## REBUTTALS TO ARCO'S GROUNDWATER INJURY REPORTS

OCTOBER 1995

**REBUTTALS TO ARCO'S GROUNDWATER INJURY REPORT  
BY REMY HENNET AND STEVEN P. LARSON**

**PREPARED FOR  
STATE OF MONTANA  
NATURAL RESOURCE DAMAGE PROGRAM**

**Figure 2**  
**Demonstration that Nonhazardous Substances Causing Injury at the Clark Fork NRDA Sites Result from Reactions Involving Hazardous Substances**

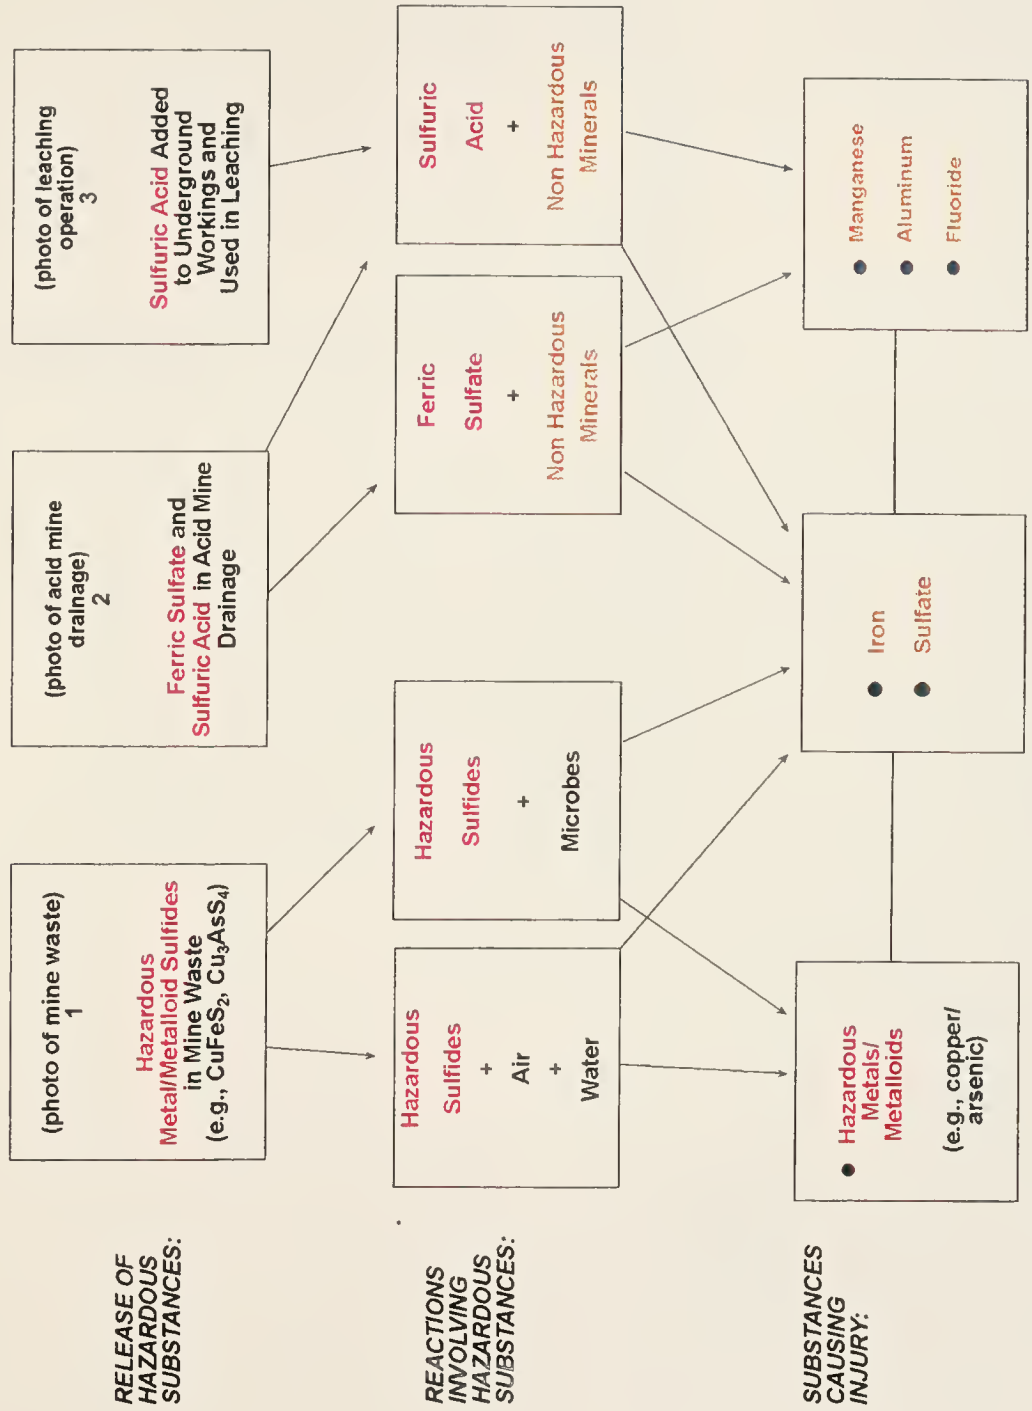
**Step 2:** Demonstrate that the nonhazardous substances causing the injury occur in the groundwater resource as a result of physical, biological, or chemical reactions resulting from or initiated by the release of hazardous substances [43 CFR § 11.62(c)(4)] (Figure 2).

Sulfuric acid is present in acid mine drainage, in the underground mine as a result of injection of sulfuric acid for extraction of copper, and in the solutions added to waste rock piles for the copper leaching operation. Sulfuric acid from these sources can dissolve pyrite, manganese sulfides and carbonates, and aluminosilicates to produce dissolved iron, manganese, aluminum, sulfate, fluoride, and other compounds (see Figure 2).

SSP&A further state that "...it is a fact that these two metals (iron and manganese) are generated by the dissolution of diverse minerals in acidic solutions, and that acidic solutions result from the oxidation of tailings material by oxygenated water. Some dissolved iron and manganese most likely has been released from the tailings to ground water in the Anaconda area." In these statements, ARCO concedes that iron and manganese in groundwater originate, at least in part, from the leaching of mine waste. They conclude, however, that "...alluvial material in the Anaconda area is naturally rich in both iron and manganese..." Again, there is nothing in the NRDA regulations that prohibits the use of naturally-occurring substances as parameters to define injury. These substances do have relevant water quality standards that are exceeded in area groundwater, and their presence in groundwater is a result of the release of hazardous substances, as outlined in Figure 2.

Figure 3  
The Copper Zone

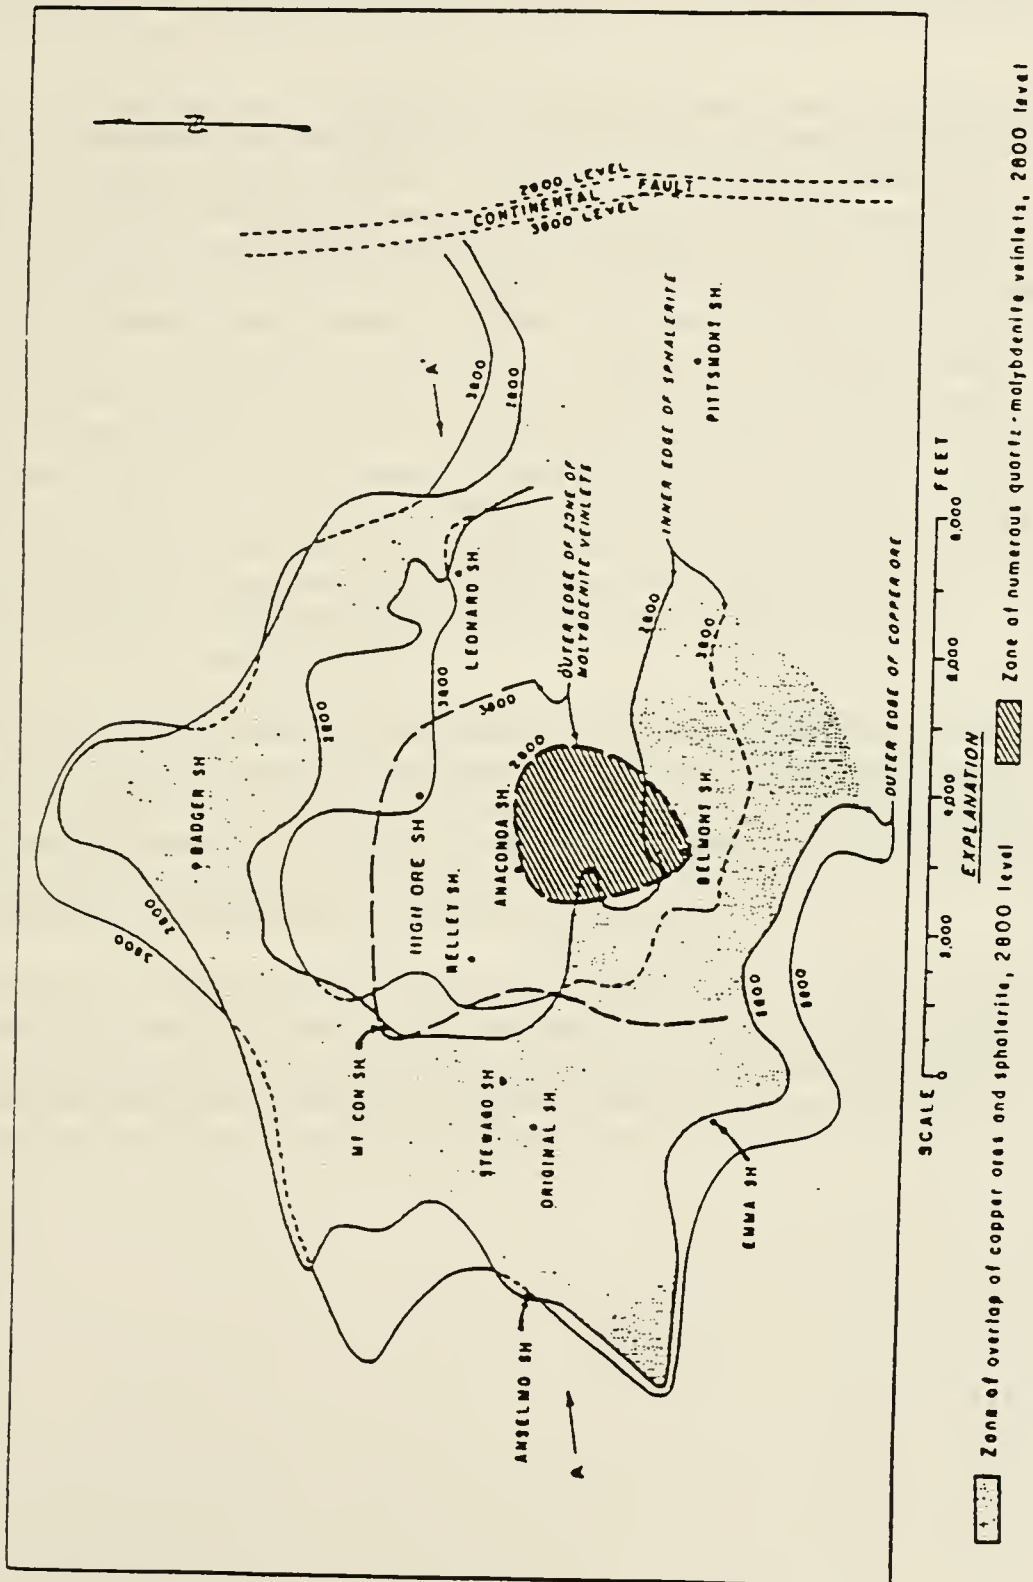
to the Meyer et al. (1968) figure, baseline control wells A, B, C, D-1, D-2, E and possibly F are all in the copper zone.

Figure 4  
 $\delta^{34}\text{S}$  vs. Sulfate, Anaconda Area Wells

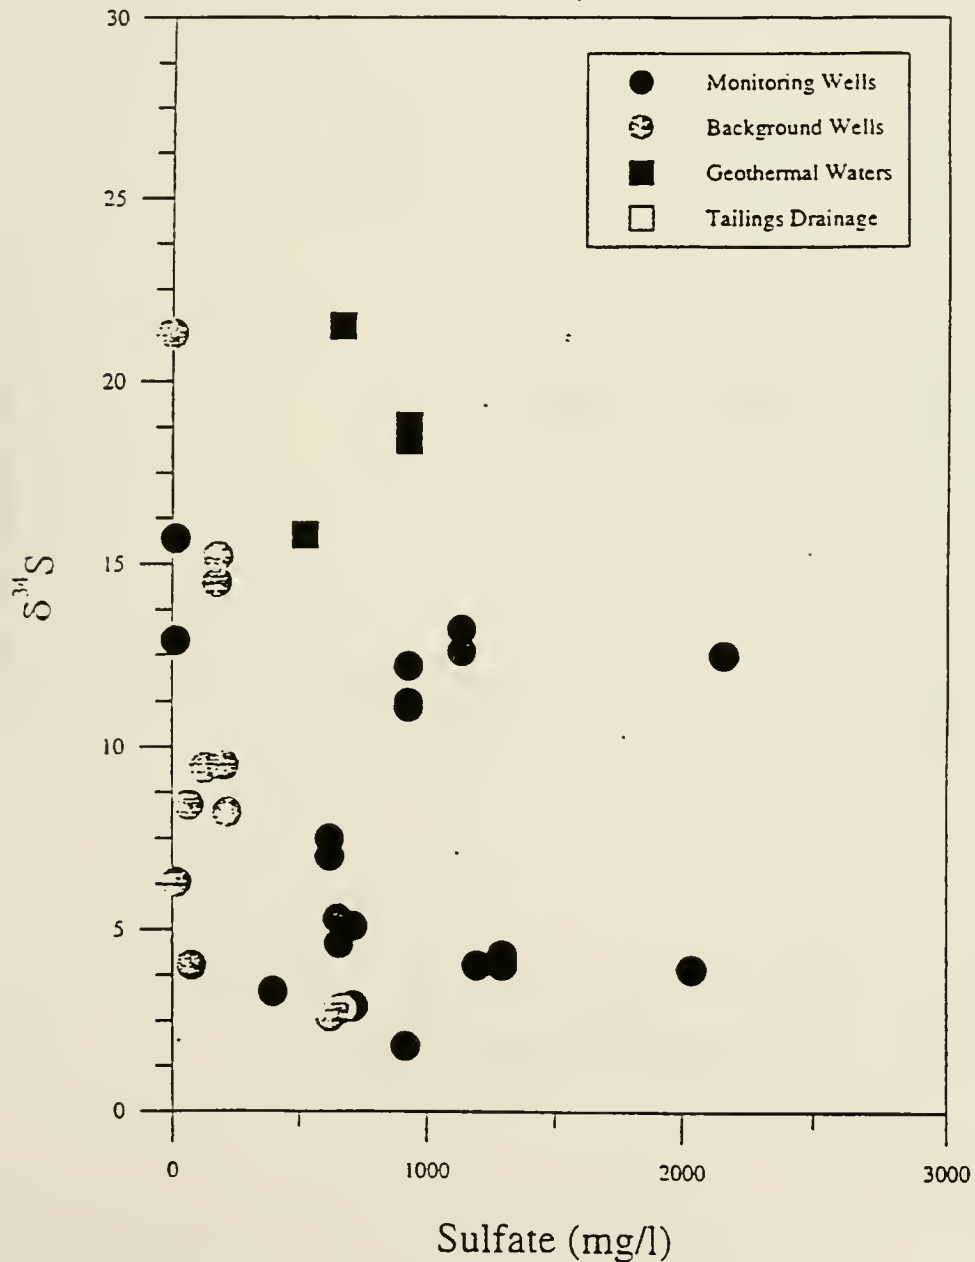
Generally,  $\delta^{34}\text{S}$  is enriched in oxidized sulfur species and minerals and depleted in reduced sulfur species and minerals. Consequently, sulfate derived from the dissolution of evaporite minerals, which may include metal sulfates in efflorescent crusts, would tend to have higher  $\delta^{34}\text{S}$  values, while sulfate derived from the oxidation of pyrite, other sulfides, organic sulfide, and sulphur in coal and oil would have lower  $\delta^{34}\text{S}$  values (Pearson and Rightmire 1980). ARCO assumes that the two relevant end-members for  $\delta^{34}\text{S}$  values is tailings water on the low end ( $\delta^{34}\text{S}$  ranges from -5.3 to 3.1 per mil CDT) and geothermal waters on the high end ( $\delta^{34}\text{S}$  ranges from 15.8 to 21.8 per mil CDT in the Anaconda area). ARCO further assumes that the  $\delta^{34}\text{S}$  values in the "wells in the Anaconda area" (Table B2-1, Hennet report) are intermediate in value and derive from the mixing of tailings and geothermal waters. Another

Figure 5  
Distribution of  $\delta^{34}\text{S}$  Values for Geothermal,  
Injured, and Baseline Waters in the  
Anaconda Area

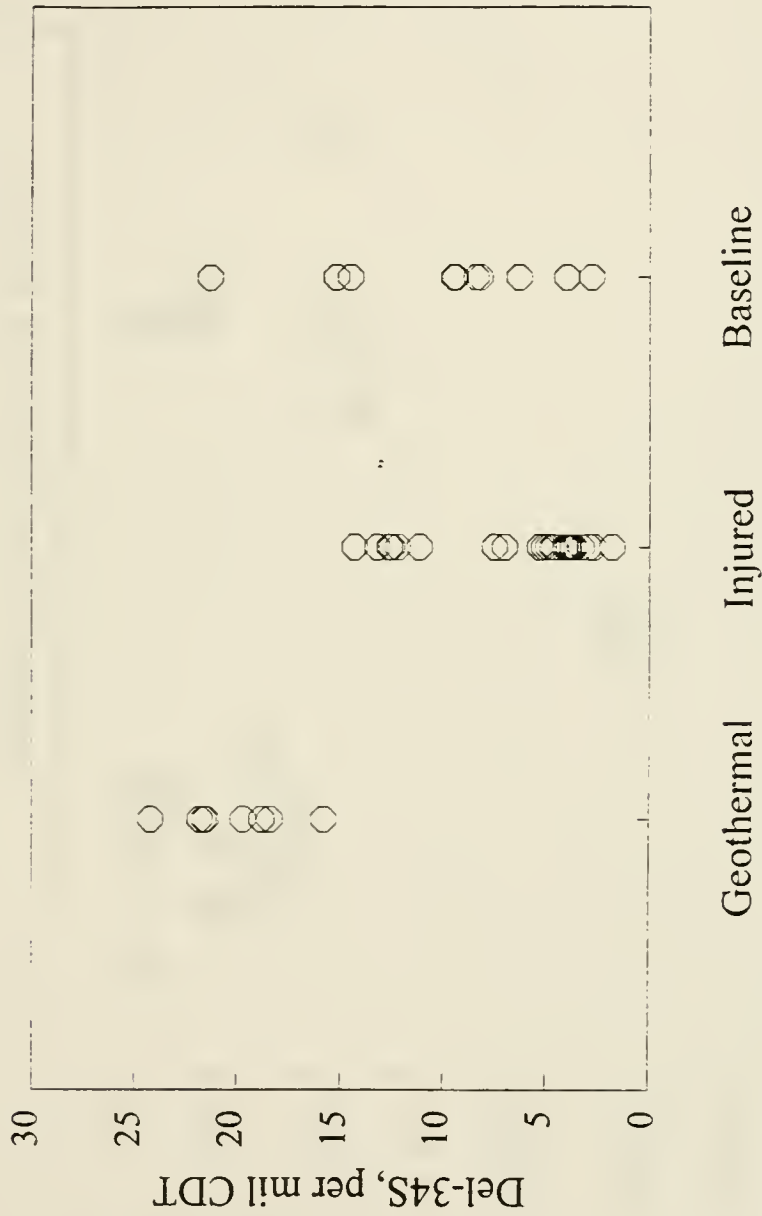
Assessment of the statistical significance of the differences between pairs of medians is provided in Tables 4 and 5. The results show that there is a statistically significant difference in sulfur isotope signatures between geothermal and either injured or baseline wells. However, there is no statistically significant difference in sulfur isotope signatures when baseline and injured wells are compared. It is therefore concluded that the background wells reflect at least as much geothermal influence as the injured wells. It also appears that the injured well samples have a highly significantly different sulfur isotope signature than samples from geothermal wells. The "geothermal" sulfate, then, is included in both the injured and background wells in the Anaconda area.

Figure 7. Well Locations from Hennet 1995, Appendix C-1

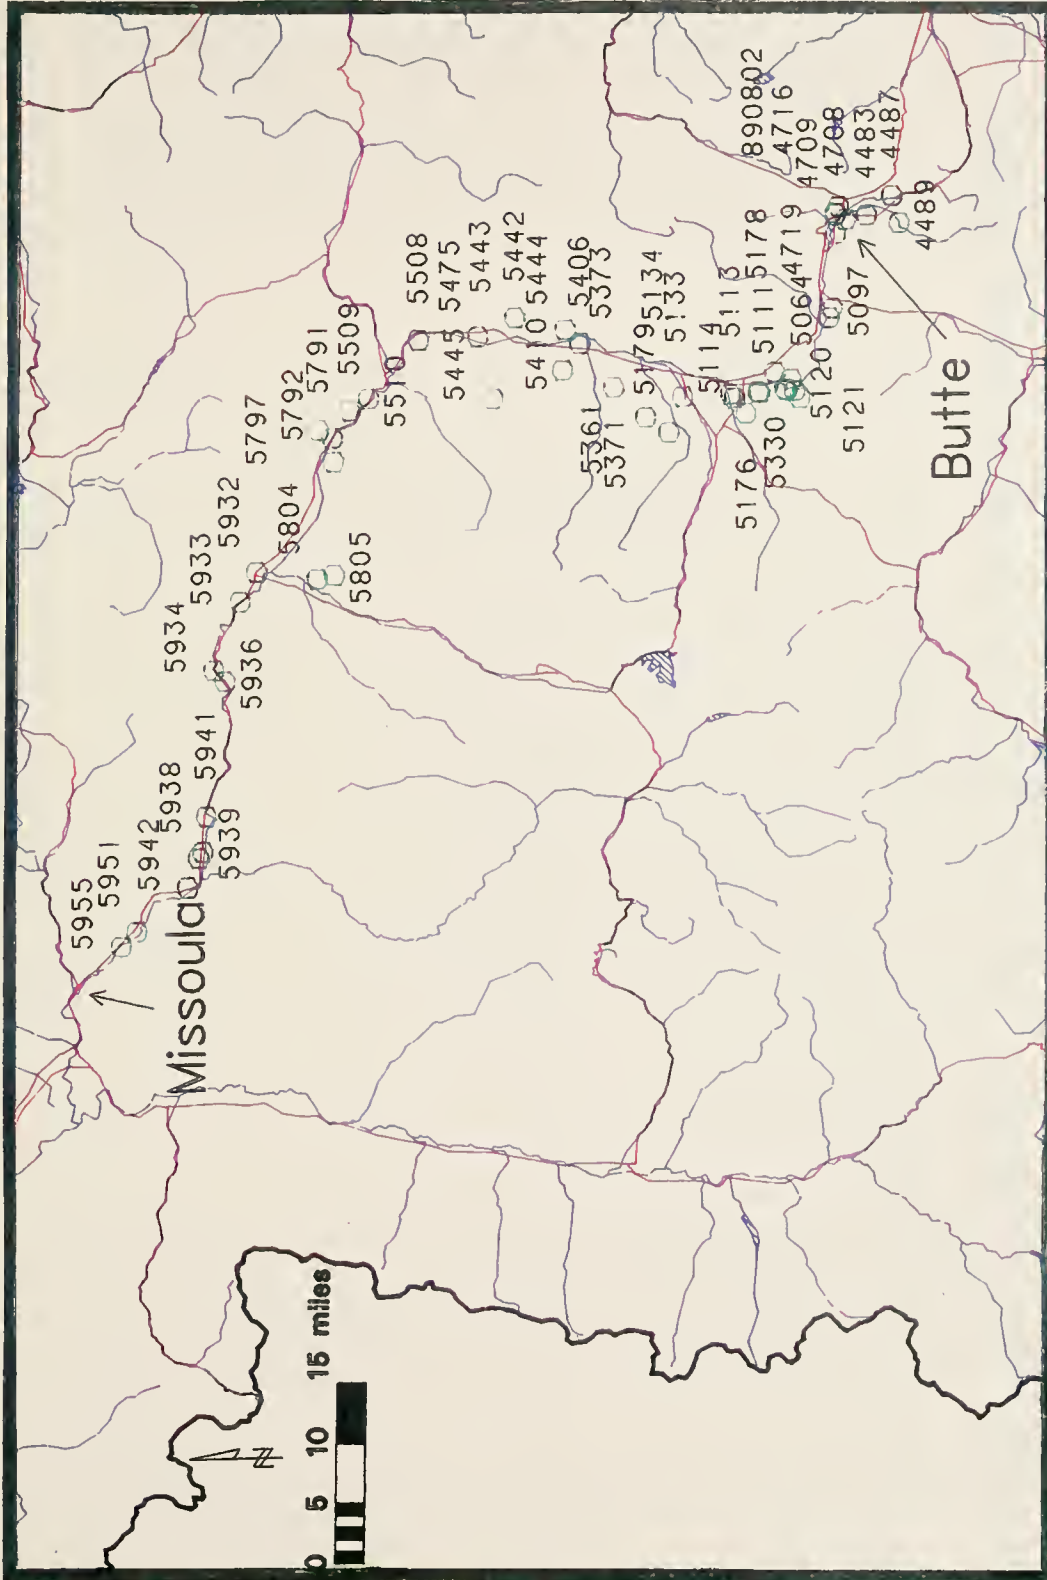
There are incorrect assumptions and conclusions inherent in ARCO's argument on this issue. First, the data set is irrelevant, arbitrary, and diffuse. Some of the "selected" wells are in known groundwater injury areas. In addition, many of the wells are immediately adjacent to the Clark Fork River (Figure 7) in areas where streamside tailings line the river. Although the State has not claimed for groundwater injury under streamside tailings, most of these areas likely contain groundwater injured from leaching and downward transport of contaminants from the streamside tailings. In a given area, some wells were excluded from, and others were included in, the cumulative frequency diagrams. No reasoning was provided for the arbitrary nature of the well selection process.

Second, the NRDA regulations do not allow or imply that the use of cumulative frequency diagrams is acceptable practice for determining which parameters can be used to define or quantify injury, nor do the regulations suggest in any way that cumulative frequency diagrams can be used to assess groundwater quality. Groundwater injury is defined according to exceedence of relevant water quality standards (43 CFR §11.62(c)(1) and §11.62(c)(2)). And

Figure 1: Location of mapped streamside tailings in the vicinity of the Rocker Site (Titan, 1995).

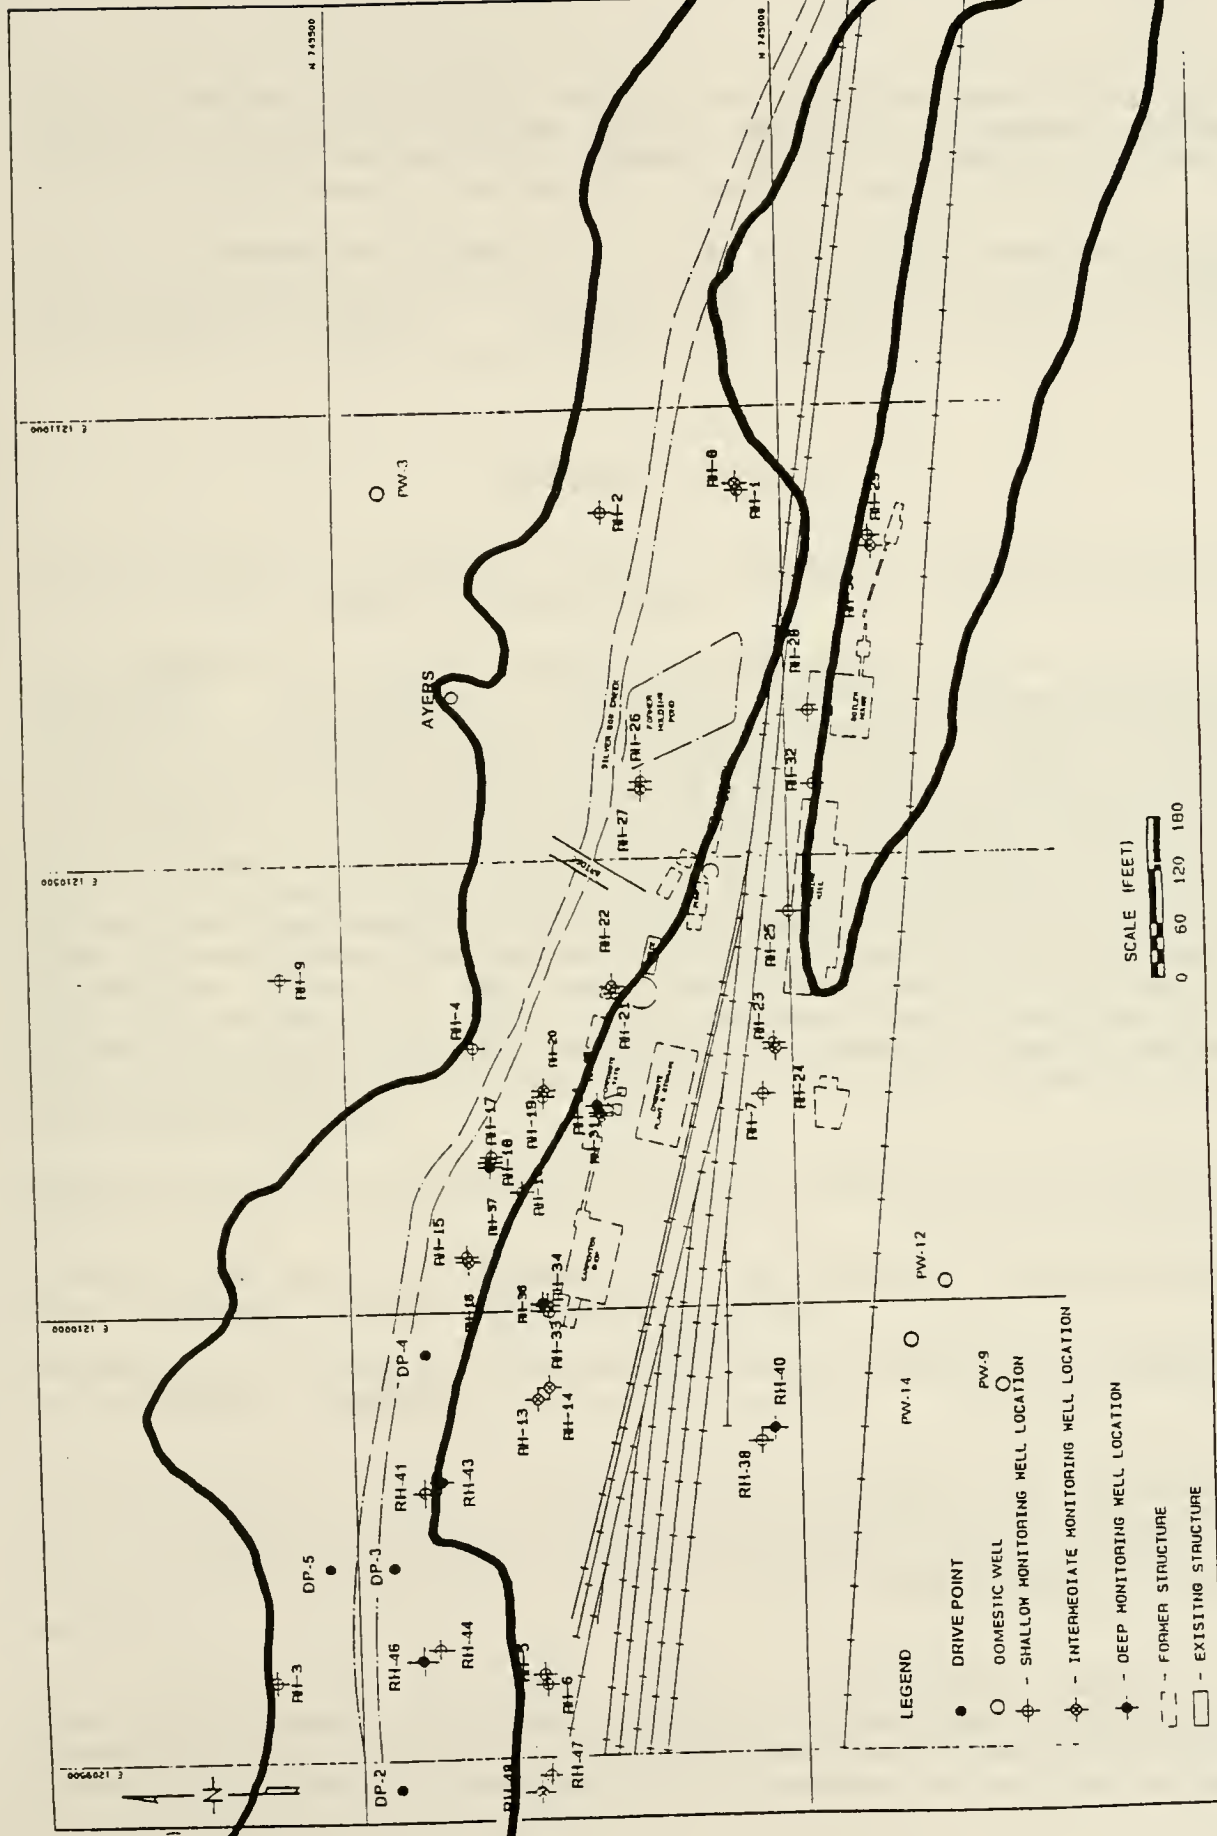
The source of the "arsenic compound" used to treat wood at the Rocker site was the arsenic plant at the Anaconda Smelter Site. This plant was used to remove some of the arsenic from the smelter emissions (Newell, 1995). Arsenic compounds derived from the flue dust would contain not only arsenic but also extremely high concentrations of hazardous materials and related metals (Woessner, 1995). Much of the groundwater contamination found at the Rocker site is most likely related to the processes used to treat wood on site. Groundwater arsenic, cadmium, copper, zinc, manganese and iron plumes all underlie the plant facilities south of Silver Bow Creek. In addition to the introduction of arsenic and other hazardous compounds from the facility source to the underlying groundwater, the site also contains streamside tailings as do the adjacent floodplains to north, east and west of the plant site. Figure 1 shows the mapped location of stream side tailings (Titan, 1995). Injured groundwater appears to be most closely associated with the Rocker facility. The presence of manganese, iron and sulfate north of the creek is most-likely do to either the transport of these compounds from the site area or the impact of streamside tailings on the underlying groundwater. Complex transport mechanisms and the release of metals from stream side tailings has been recognized by Benner (1994) and Smart (1995) at the Miles Cross Silver Bow Creek floodplain research site located west of Rocker.
